The Sizewell C Project

2.8 Two Village Bypass Plans For Approval

July 2021

Two Village Bypass Plans For Approval – Revisions Schedule

DRAWING TITLE:
TWO VILLAGE BYPASS PROPOSED GENERAL ARRANGEMENT AND PROFILES SHEET 1 OF 2

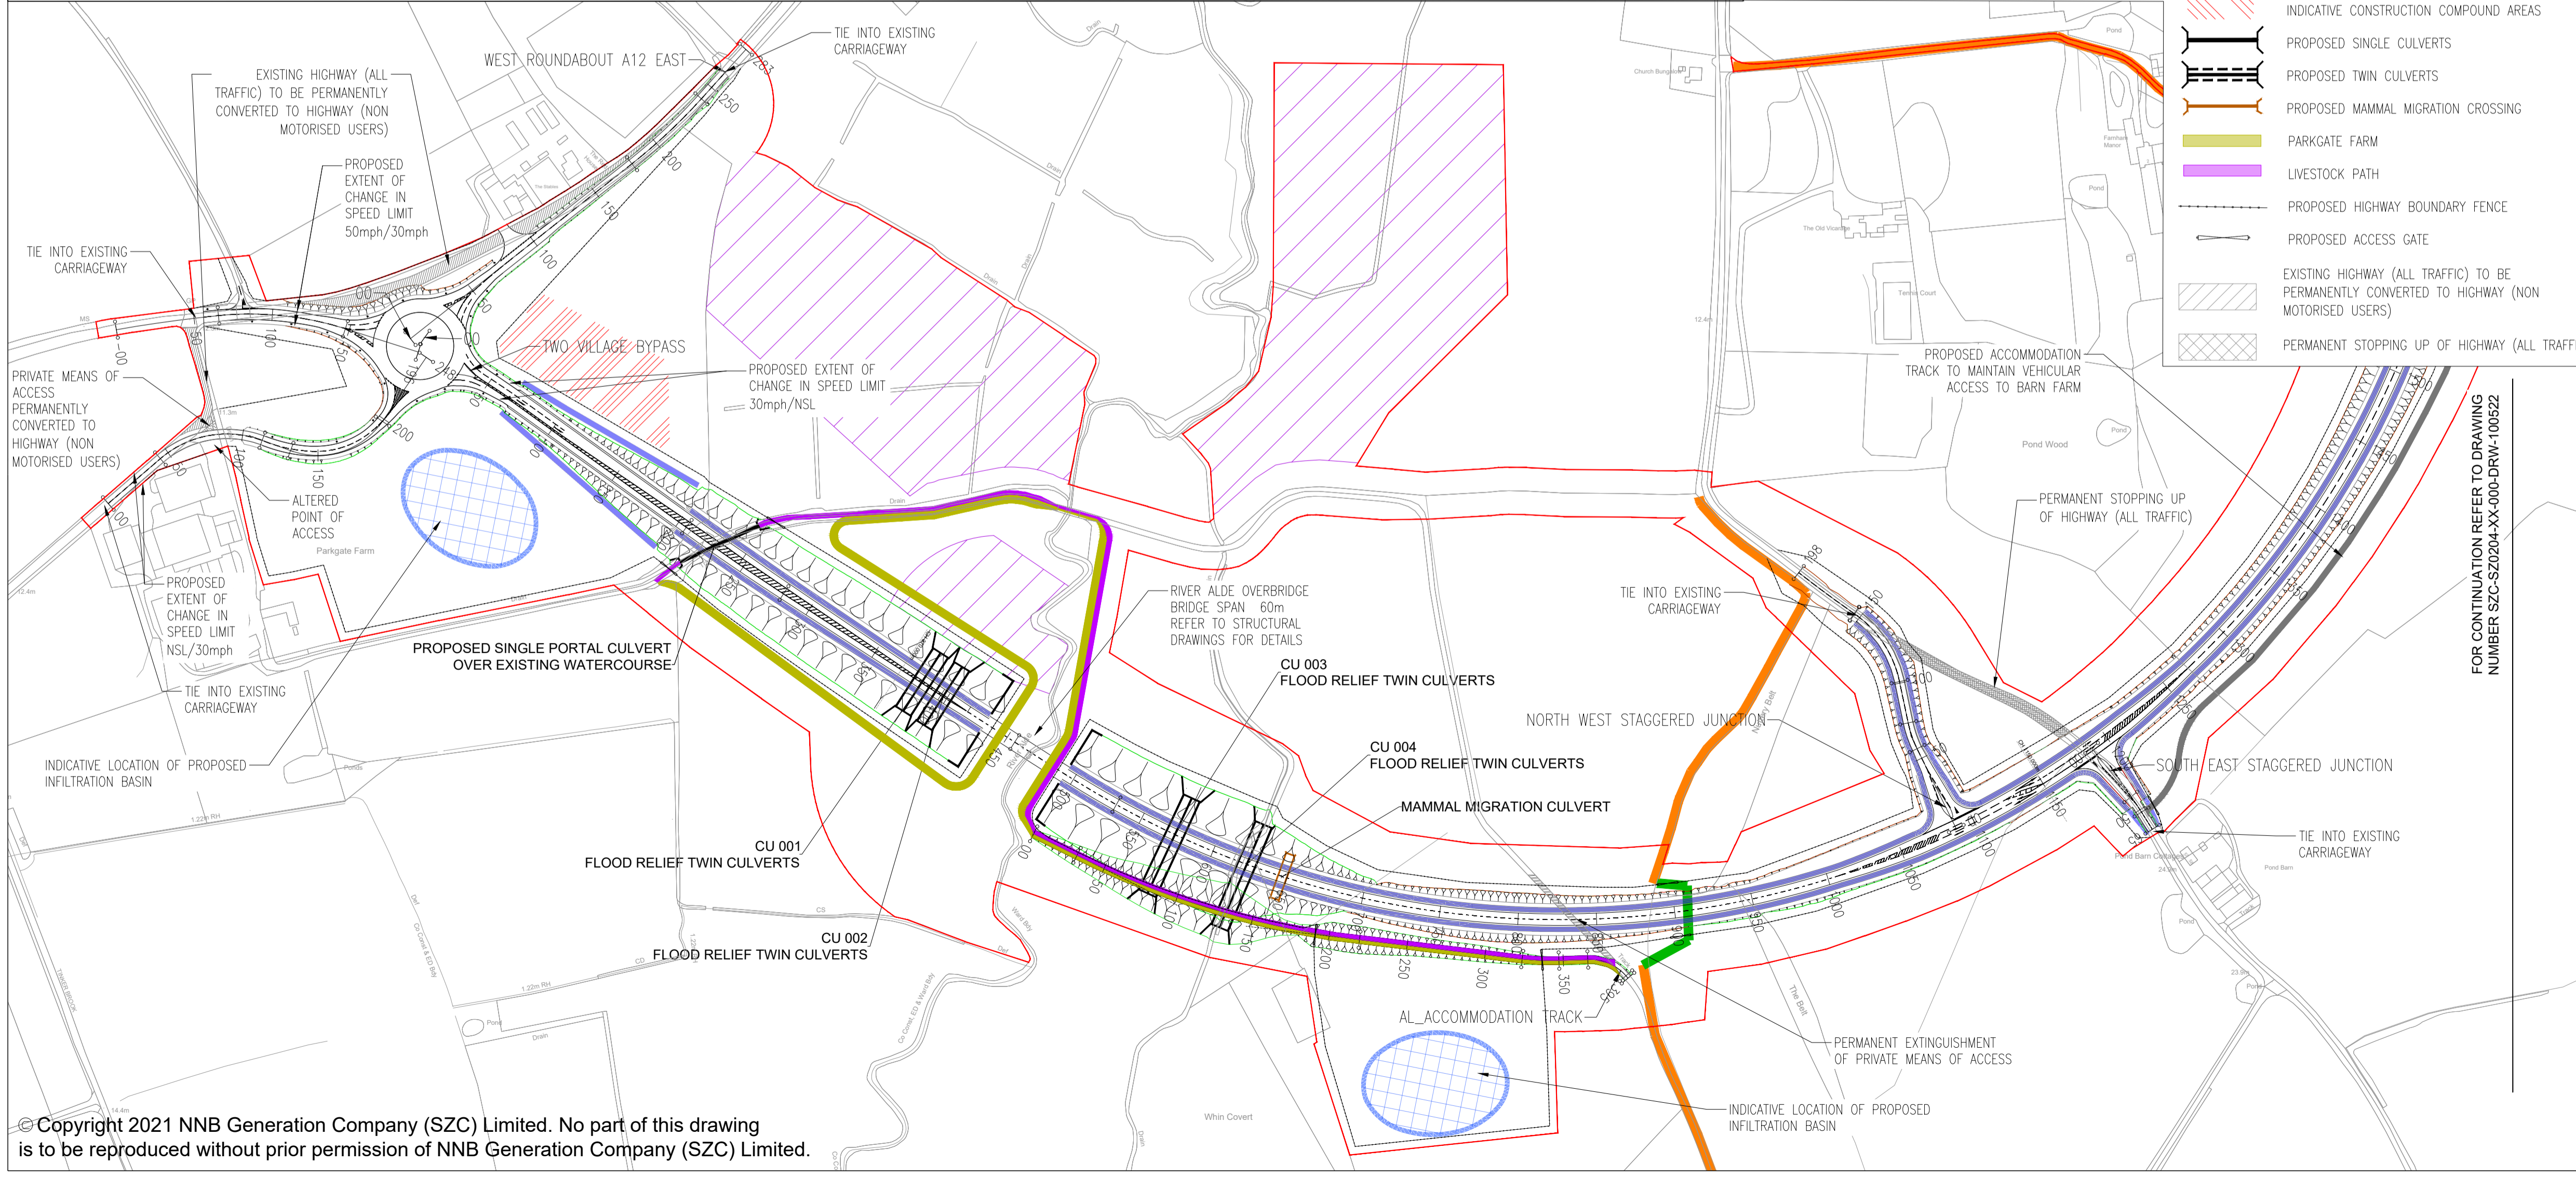
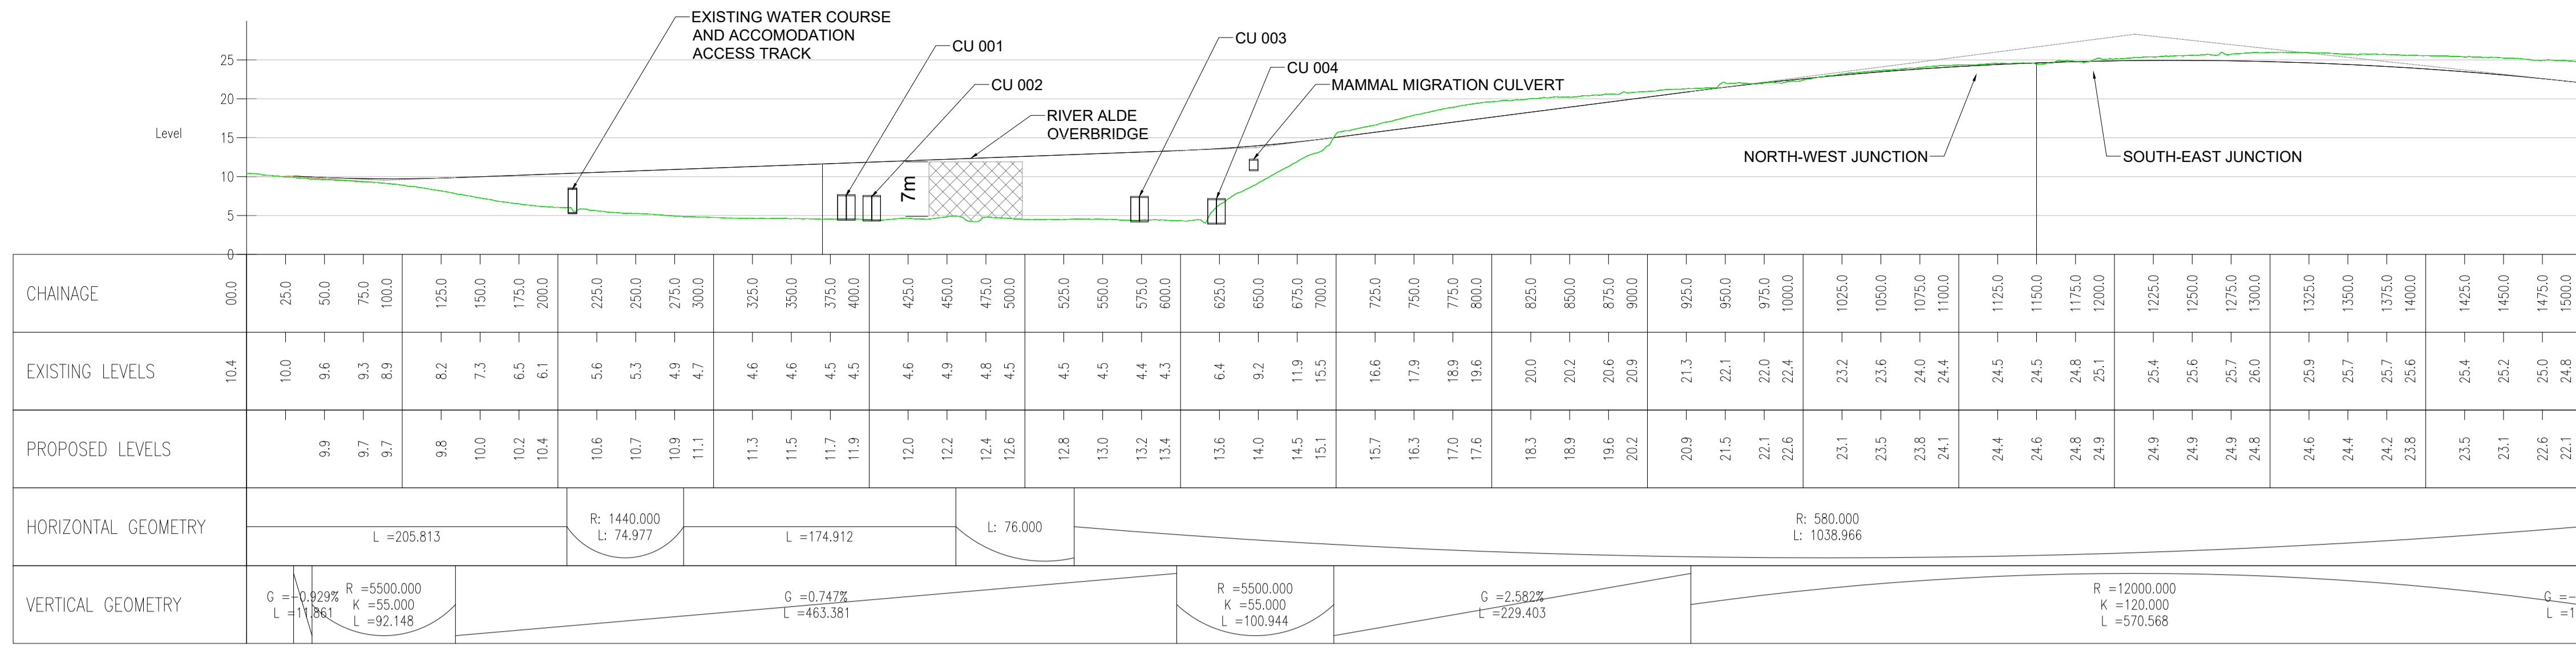
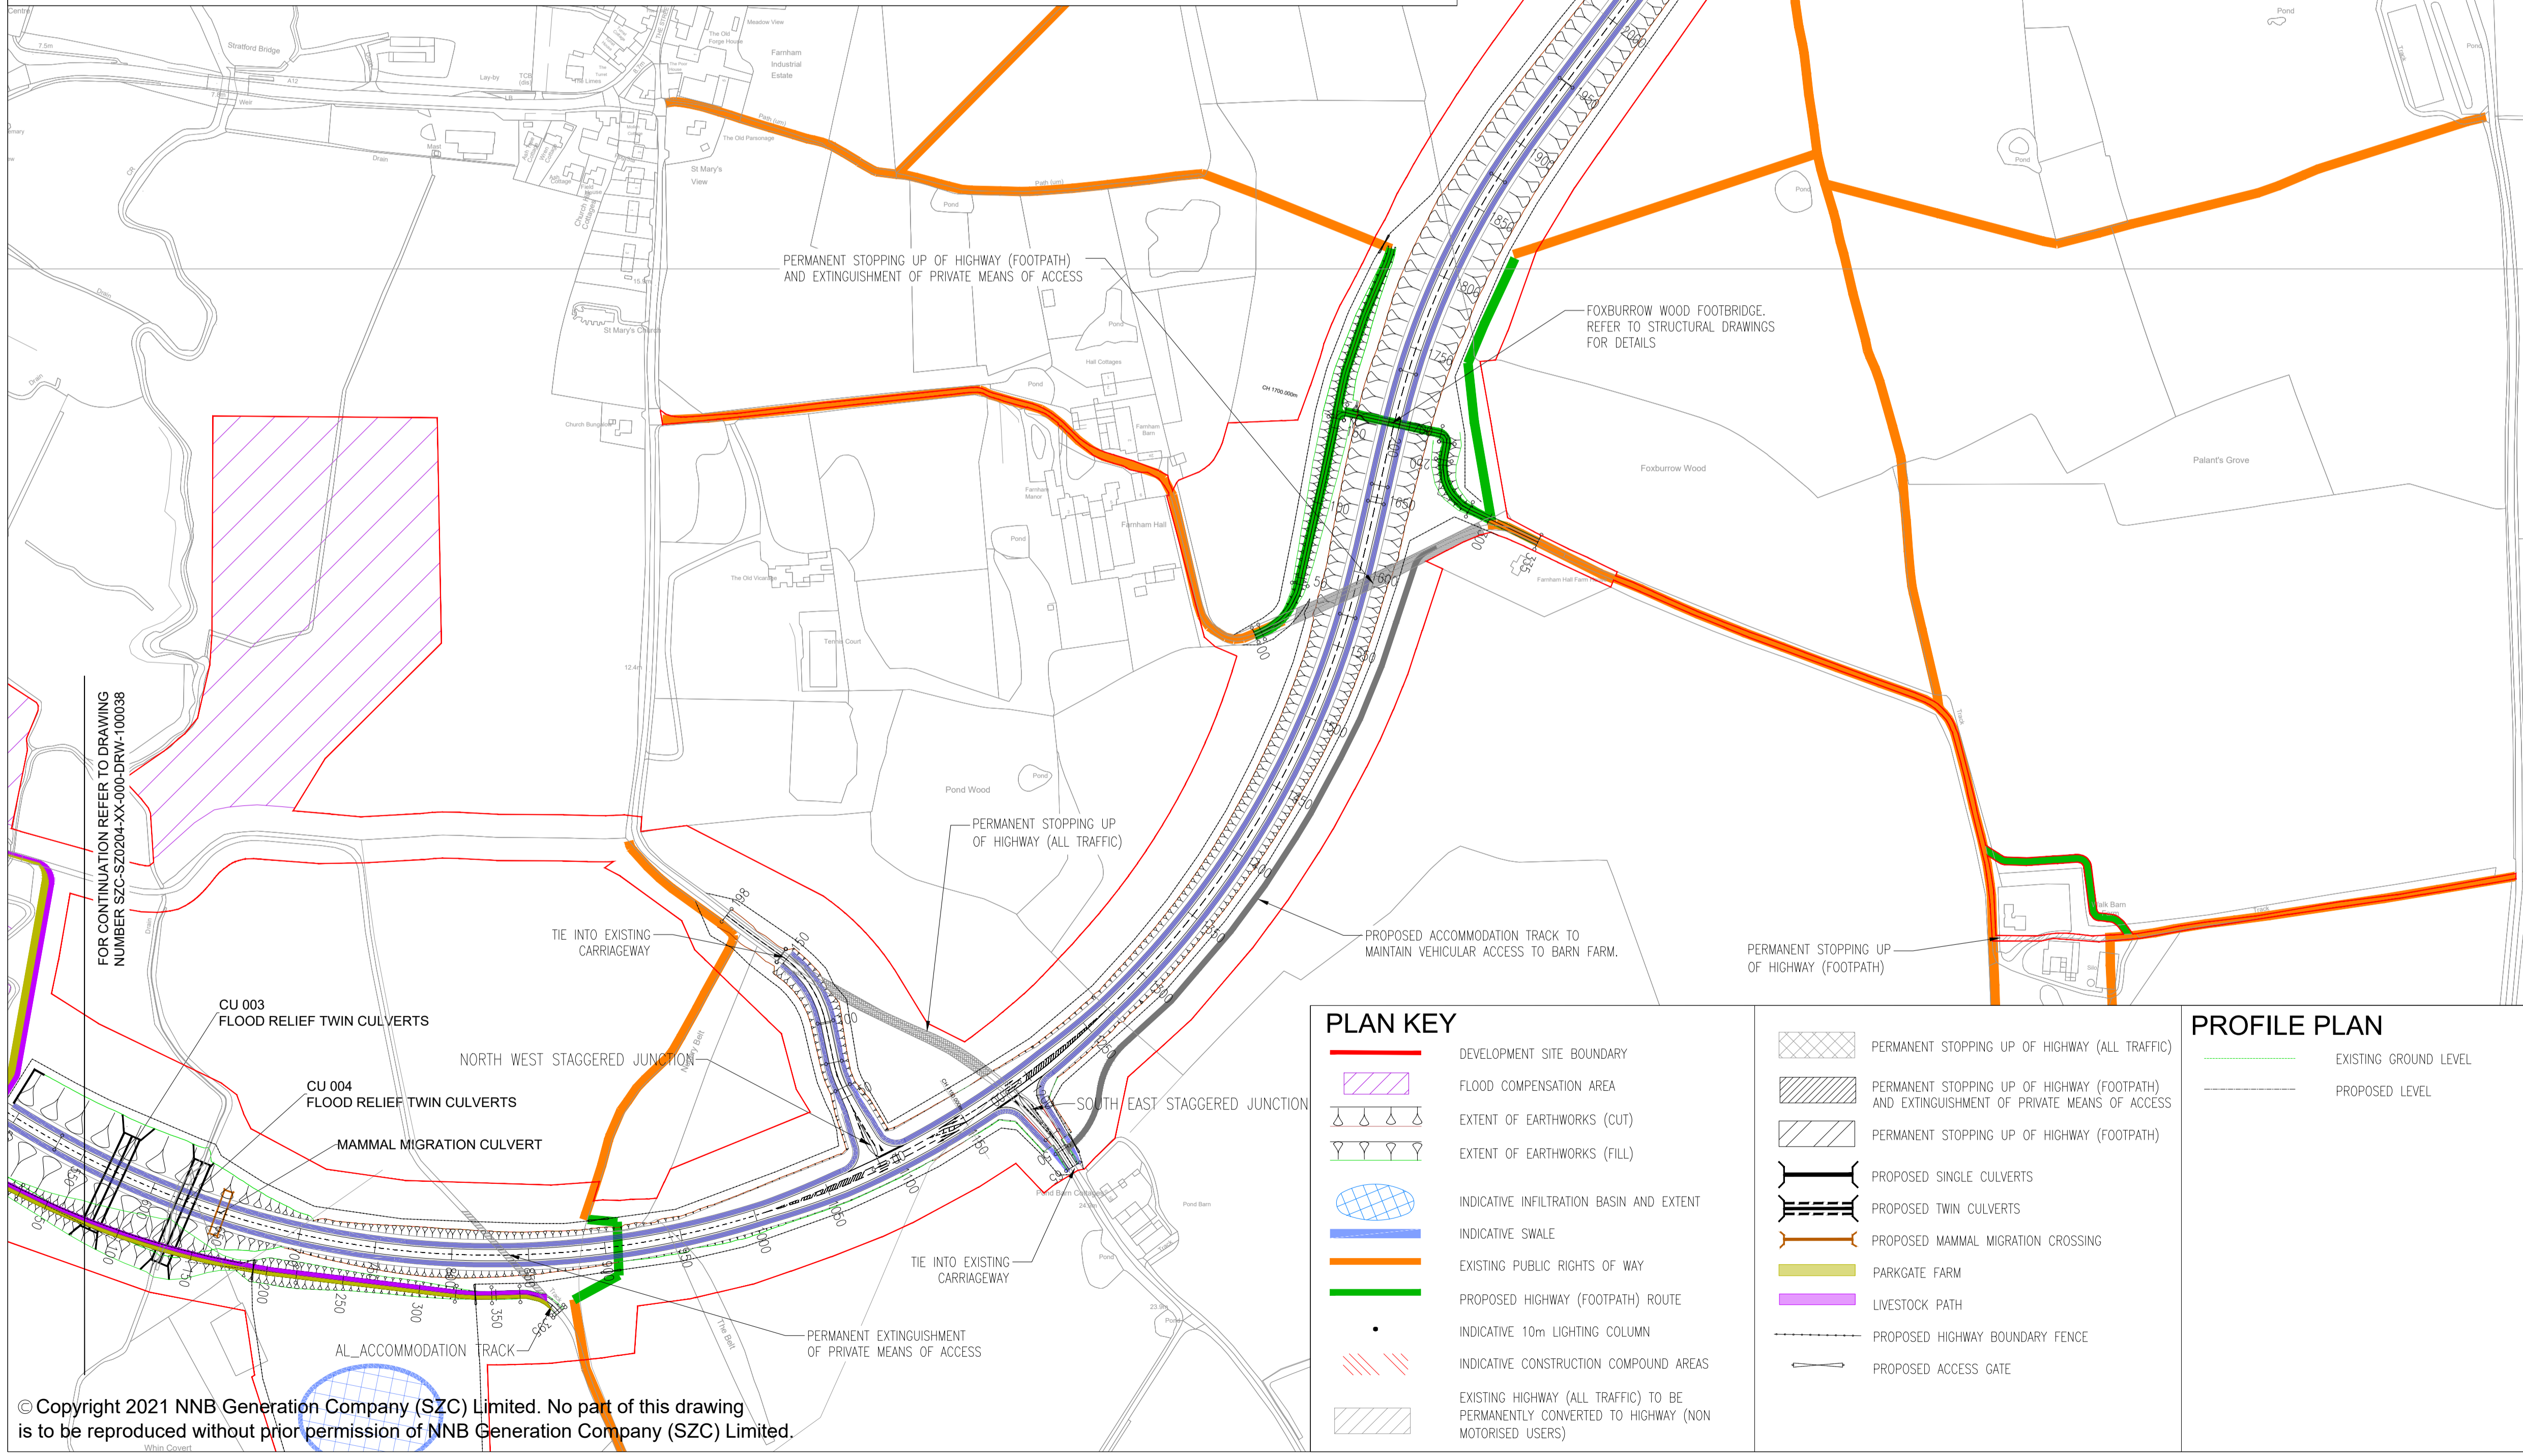
Drawing Number	Revision	Drawing Title	Amendments
SZC-SZ0204-XX-000-DRW-100038	02	Two Village Bypass Proposed General Arrangement And Profiles - Sheet 1 of 2	Increased Order Limits due to design changes, additional indicative western construction compound and changes to key.
SZC-SZ0204-XX-000-DRW-100522	02	Two Village Bypass Proposed General Arrangement And Profiles - Sheet 2 of 2	Increased Order Limits due to design changes, additional indicative western construction compound and changes to key.
SZC-SZ0204-XX-000-DRW-100039	02	Two Village Bypass A12/A1094 Eastern Roundabout Proposed General Arrangement	Change to key ('Indicative Construction Compound Areas')
SZC-SZ0204-XX-000-DRW-100040	02	Two Village Bypass A12 Western Roundabout Proposed General Arrangement	Changes to key
SZC-SZ0204-XX-000-DRW-100450	01	Two Village Bypass A12/A1094 Eastern Roundabout Proposed Profiles	No updates made.
SZC-SZ0204-XX-000-DRW-100451	01	Two Village Bypass A12 Western Roundabout Proposed Profiles	No updates made.
